PRODUCT/PROCESS CHANGE NOTICE (PCN)

PCN #: Q1703-02 DATE: 2-May-2017 Product Affected: F1423NBGI(8) Date Effective: 2-Aug-2017	MEANS OF DISTINGUISHING CHANGED DEVICES: <input type="checkbox"/> Product Mark <input type="checkbox"/> Back Mark <input type="checkbox"/> Date Code <input checked="" type="checkbox"/> Other Materials used is traceable through Assembly Lot#
--	---

ATTACHMENT I - PCN # : Q1703-02

PCN Type: Change of Die Size

Detail Of Change:

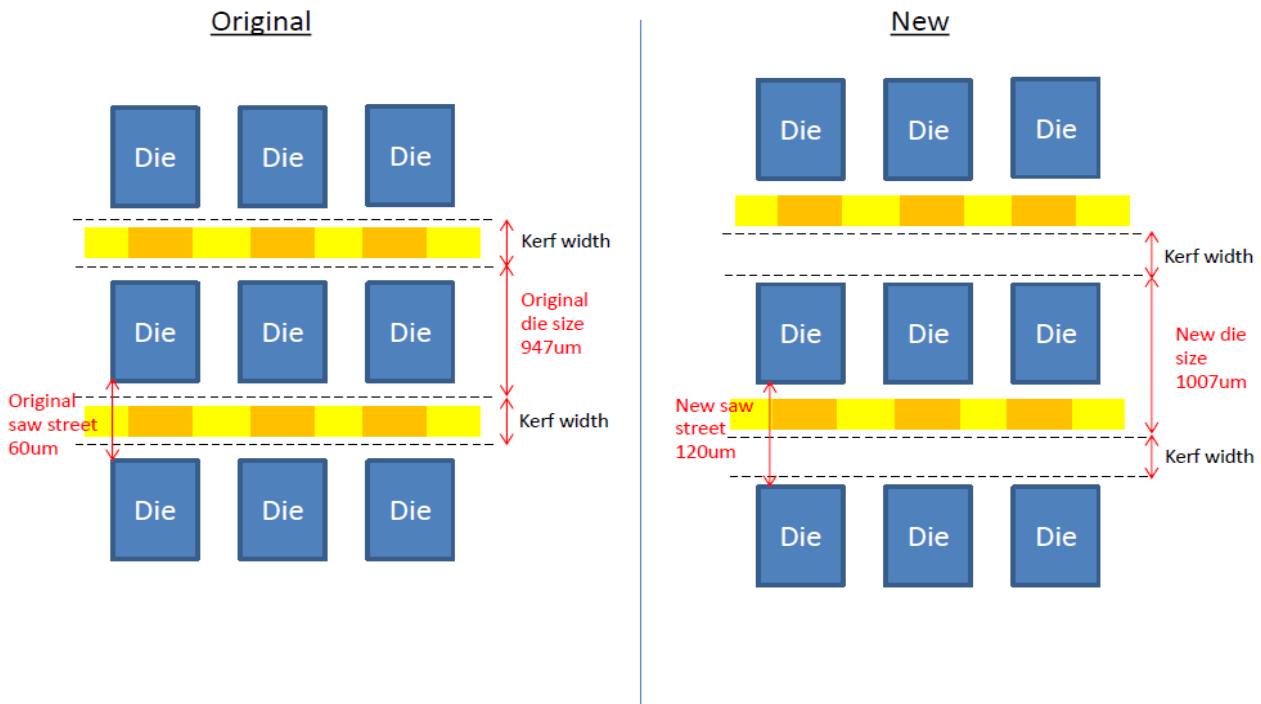
This notification is to advise our customers that select IDT parts are being converted to a 530um x 1007um die size from a 530um x 947um die size as a result of the increased to the saw street width dimension. This change is being made to improve manufacturing capability. Refer to the below illustration.

There is no change to the product design or process technology.
There is also no change to the package, backend manufacturing process or the the data sheet and ordering part number.
